ADAMSTOWN BOULEVARD PHASE 1

GRANT REF: SDZ22A/0007

INTRODUCTION - PLANNING CONDITIONS

This document is in response to Condition 7 and prepared by McCauley Daye O'Connell Architects.

2.2 HOUSE TYPE H2AB1 AMENDMENTS TO PLANNING APPLICATION

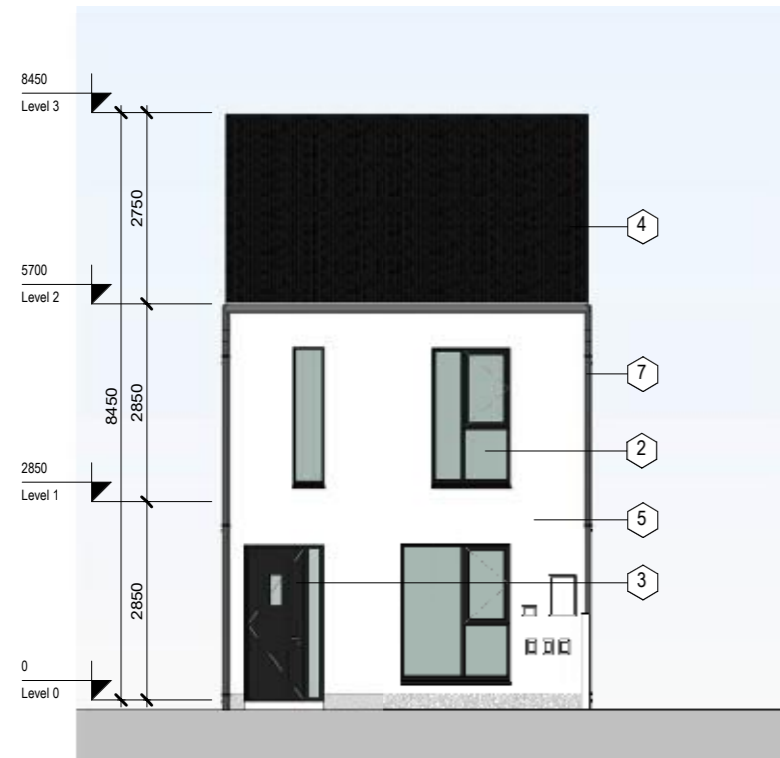
- Brick plinth and window surround introduced
- Plinth to rear removed
- Door side panel removed
- Lower ridge level

2.3 HOUSE TYPE H2AC AMENDMENTS TO PLANNING APPLICATION

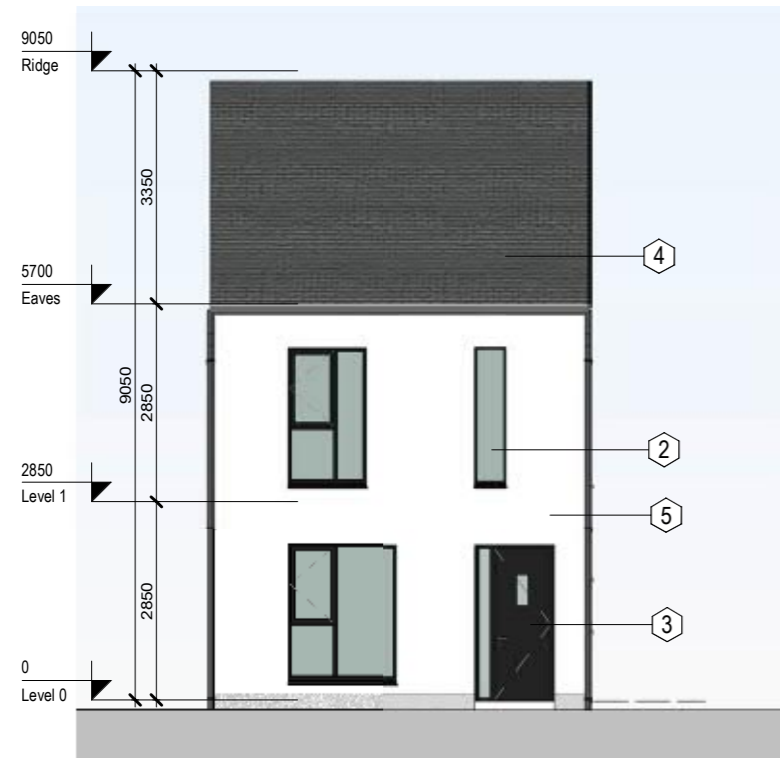
- Brick plinth and window surround introduced
- Plinth to rear removed
- Door side panel removed
- Lower ridge level

2.4 HOUSE TYPE H2AC1 AMENDMENTS TO PLANNING APPLICATION

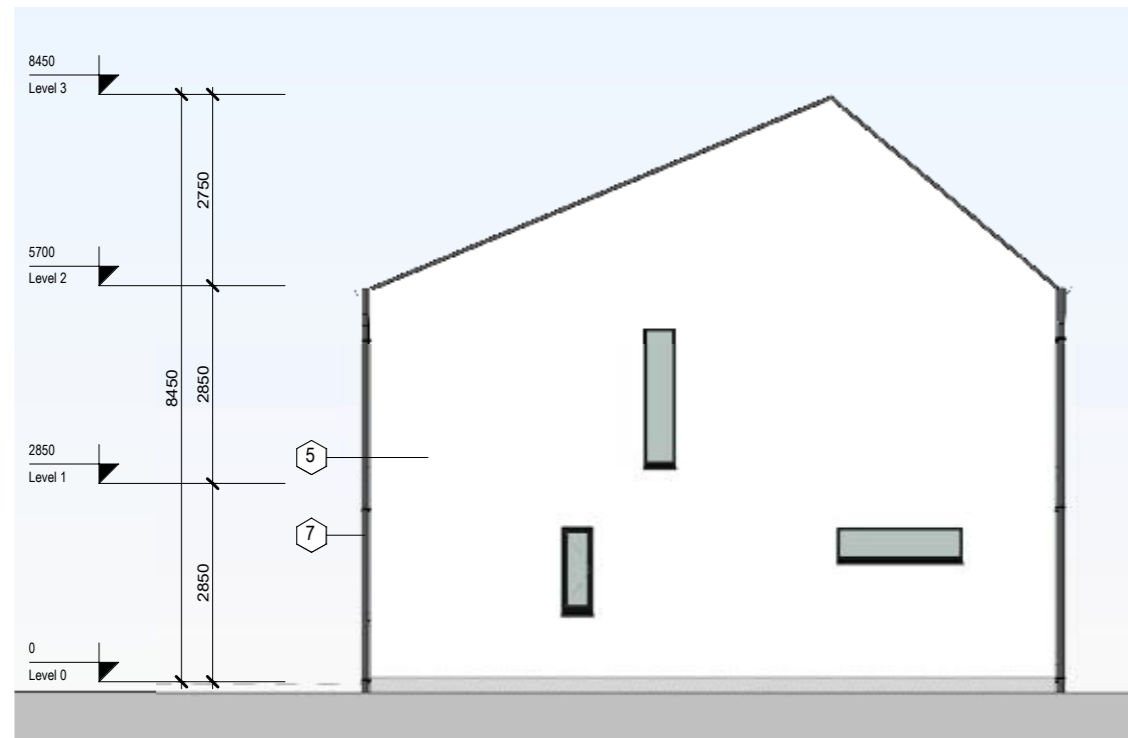
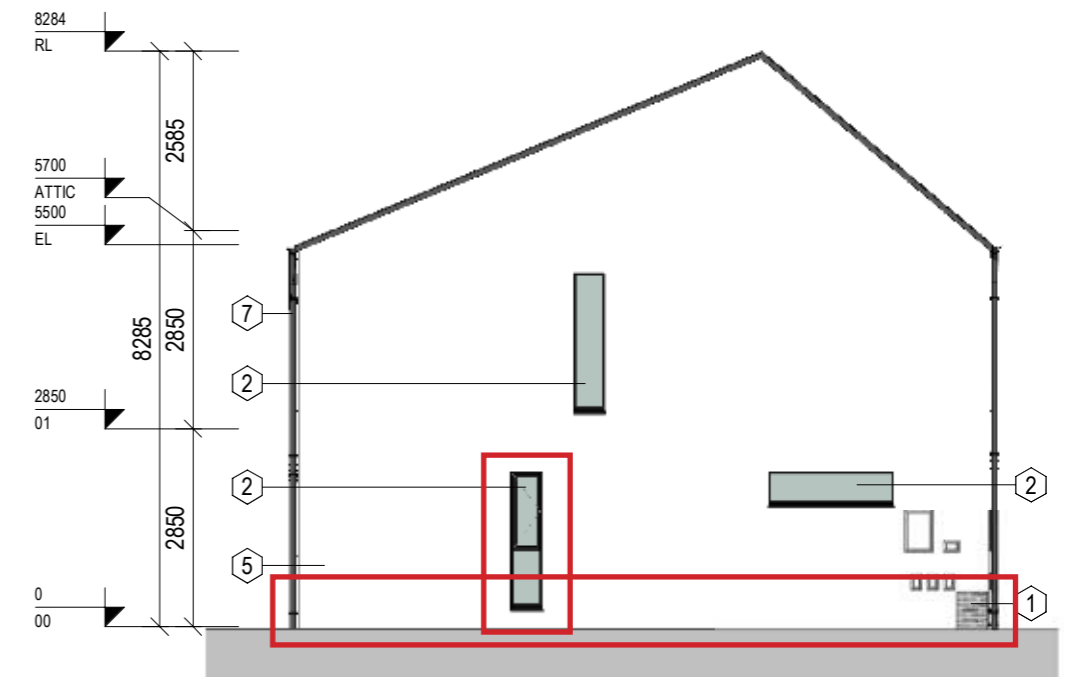
- Brick plinth and window surround to front introduced
- Plinth to rear and side removed
- Window reduced in size

2.5 HOUSE TYPE H2AC2 AMENDMENTS TO PLANNING APPLICATION

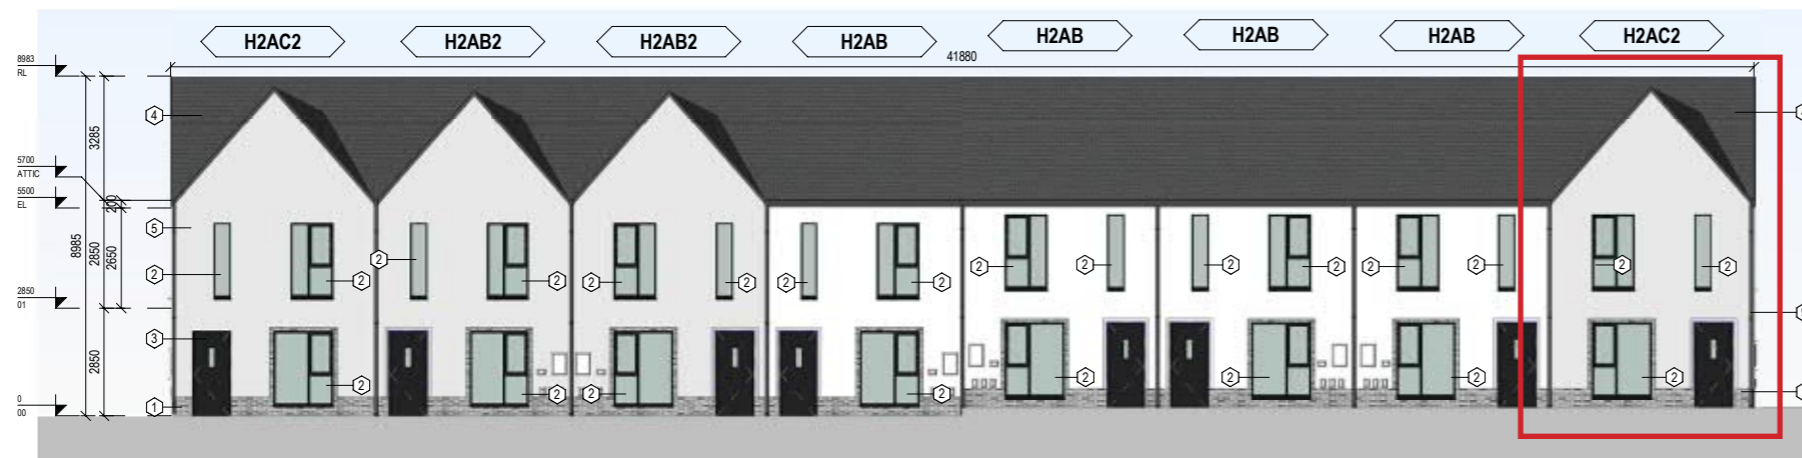
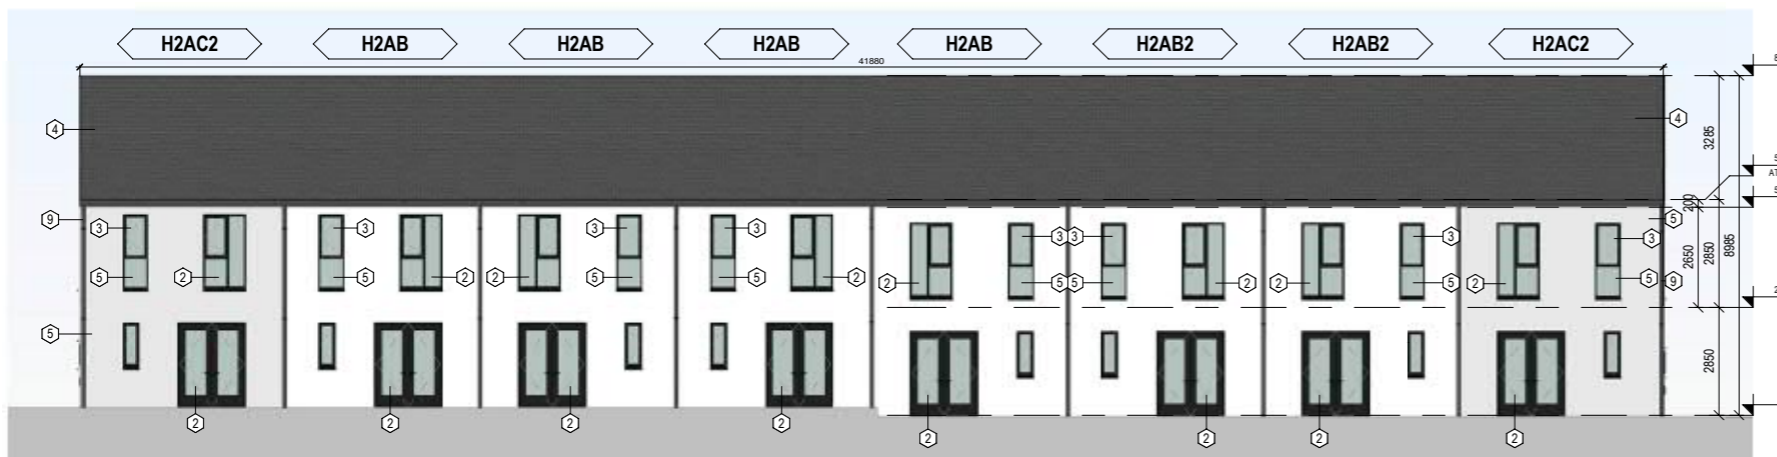
- Type H2AC changed to H2AC2
- Gable introduced to front of terrace T5E

2.6 HOUSE TYPE H2AD AMENDMENTS TO PLANNING APPLICATION

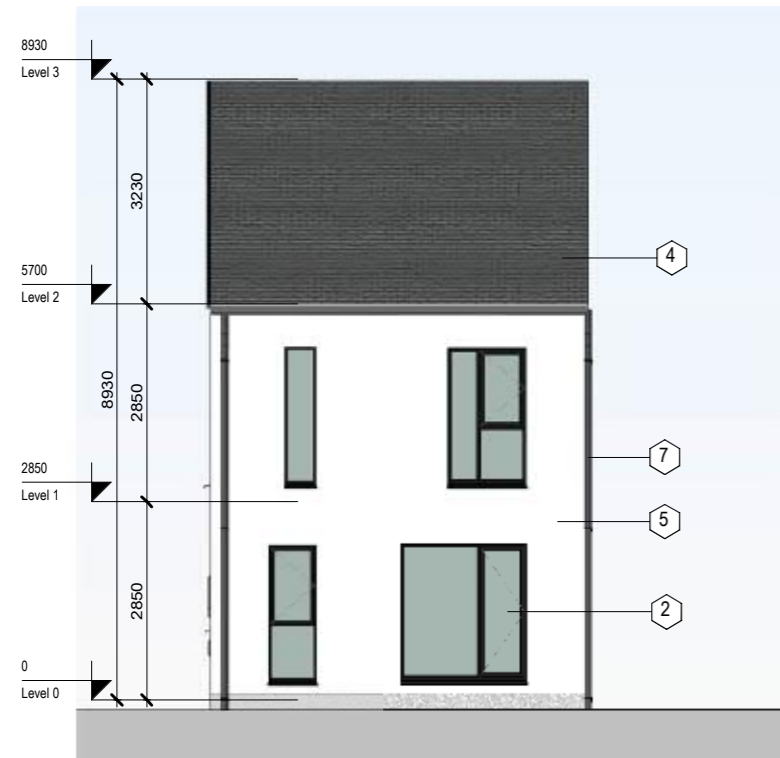
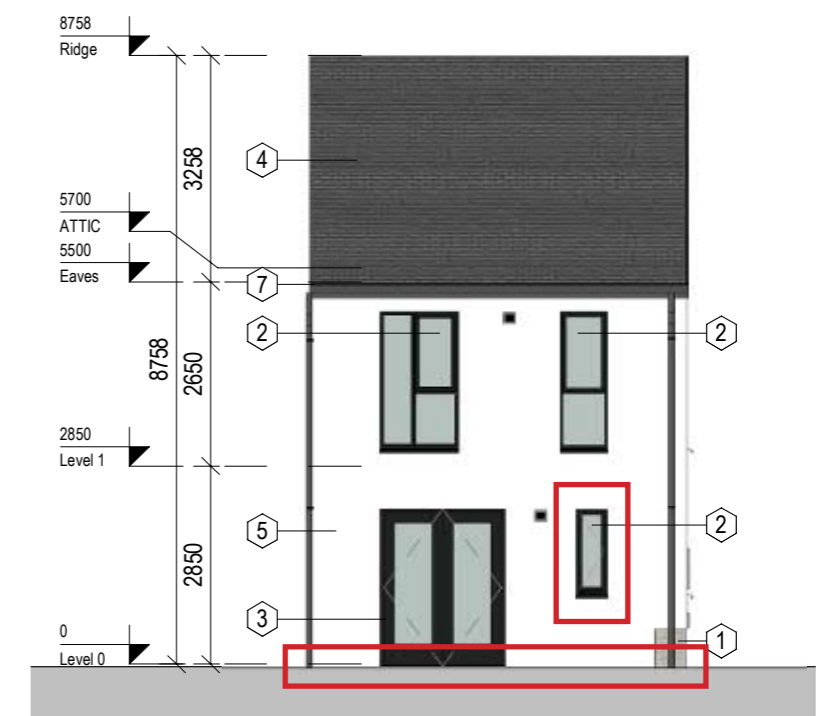
- Brick plinth and window surround introduced
- Plinth to rear removed
- Window type changed
- Lower ridge level

2.6 HOUSE TYPE H2AD AMENDMENTS TO PLANNING APPLICATION

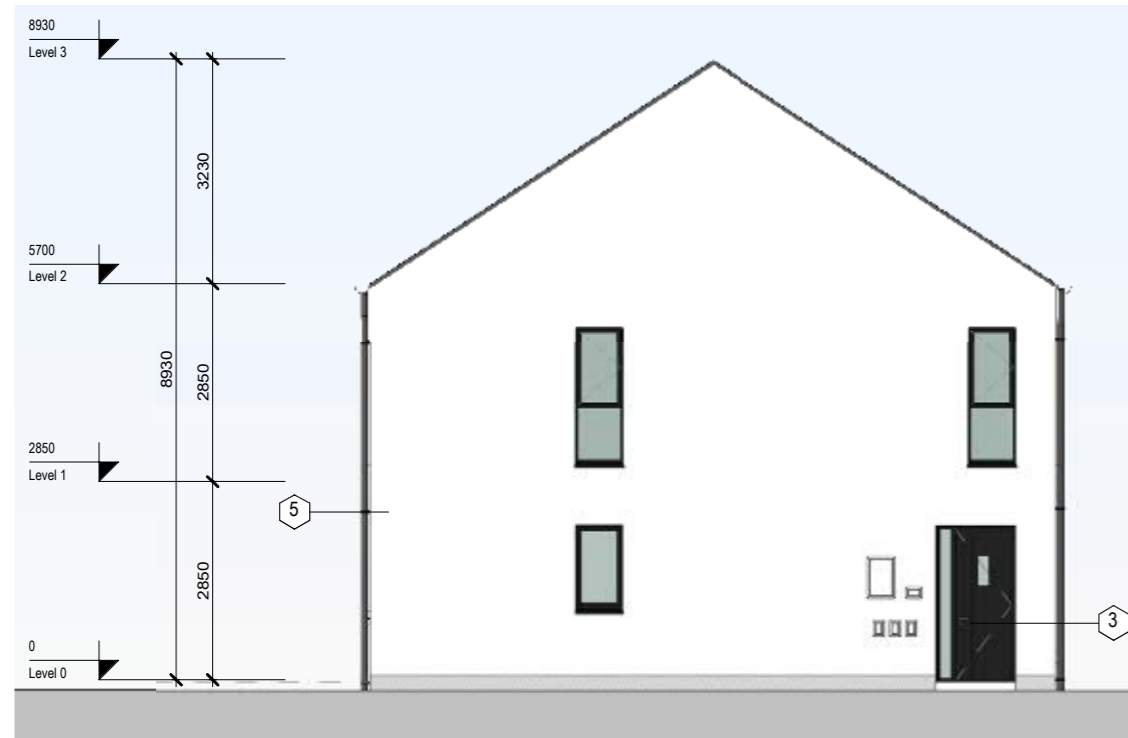
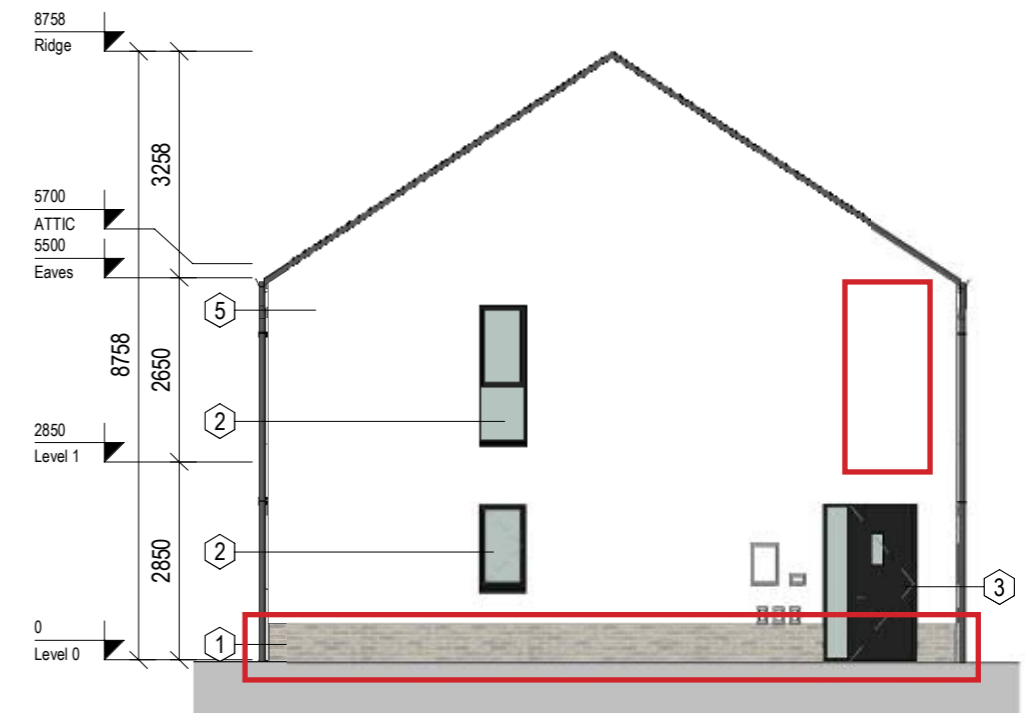
- Brick plinth introduced
- Window omitted

2.7 HOUSE TYPE H2AD1 AMENDMENTS TO PLANNING APPLICATION

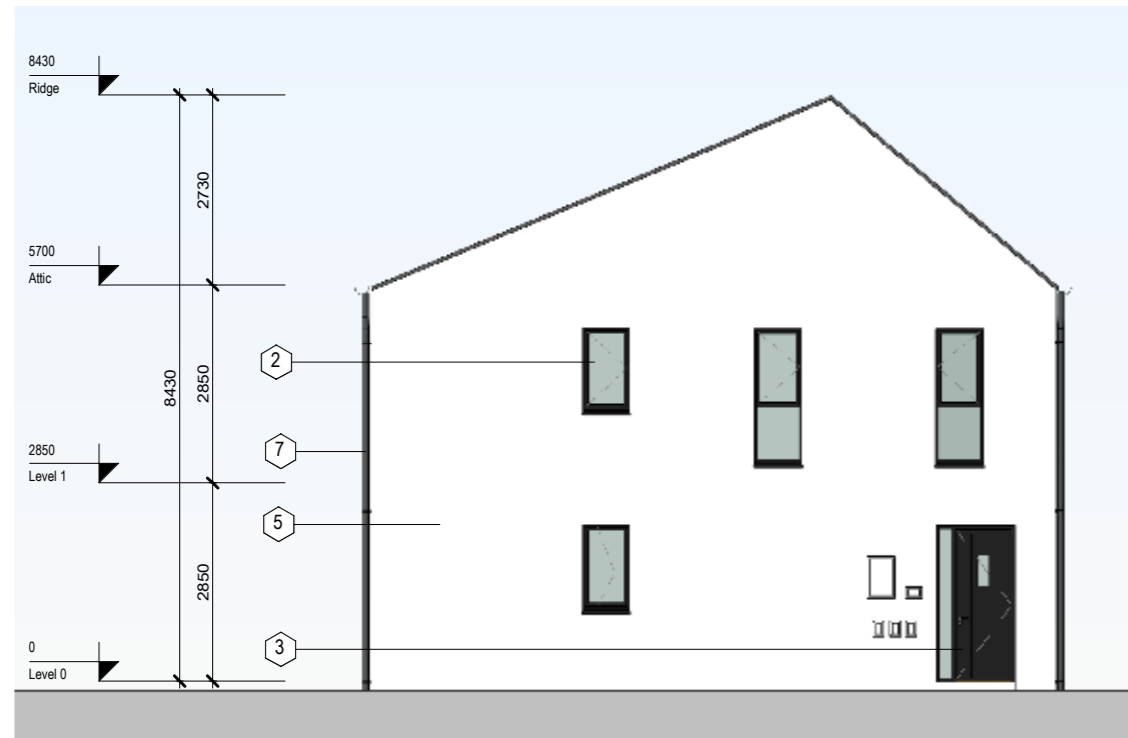
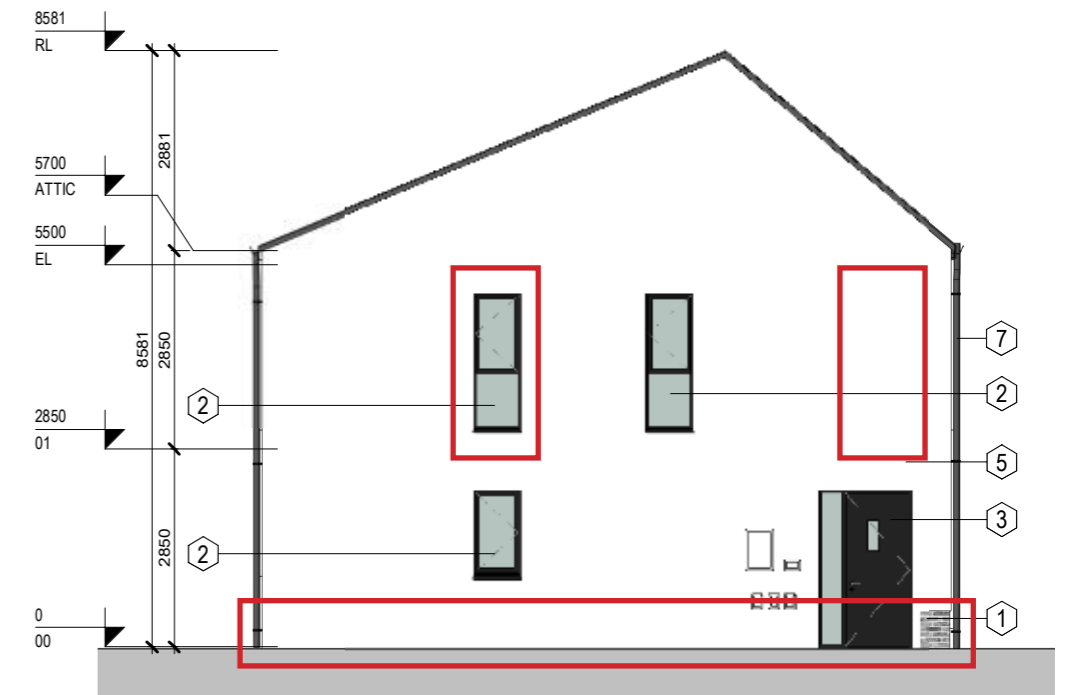
- Brick plinth introduced
- Window type changed
- Window omitted
- Higher ridge level

3.1 HOUSE TYPE H3AB AMENDMENTS TO PLANNING APPLICATION

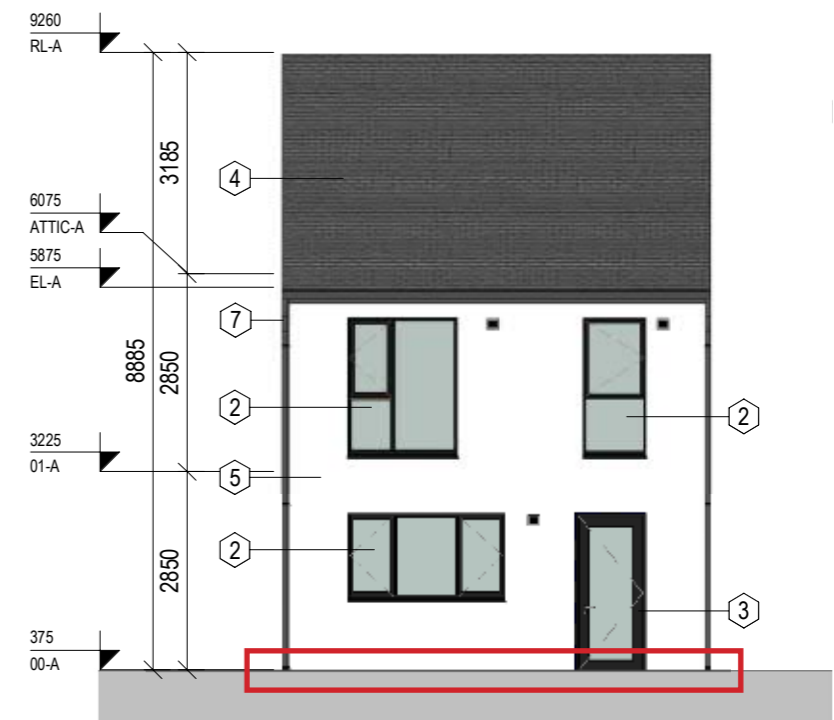
- Brick plinth introduced
- Plinth to rear removed
- Entrance door side panel removed
- Higher ridge level
- Coloured render introduced

3.2 HOUSE TYPE H3AB1 AMENDMENTS TO PLANNING APPLICATION

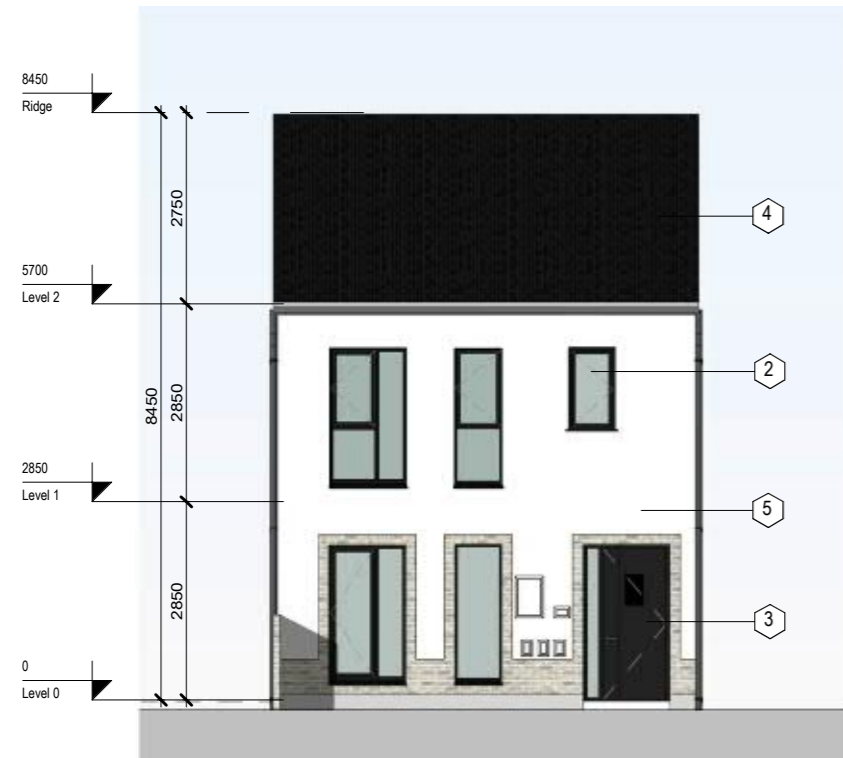
- Plinth to rear removed
- Entrance door side panel removed
- Window type changed
- Front door brick surround omitted
- Higher ridge level
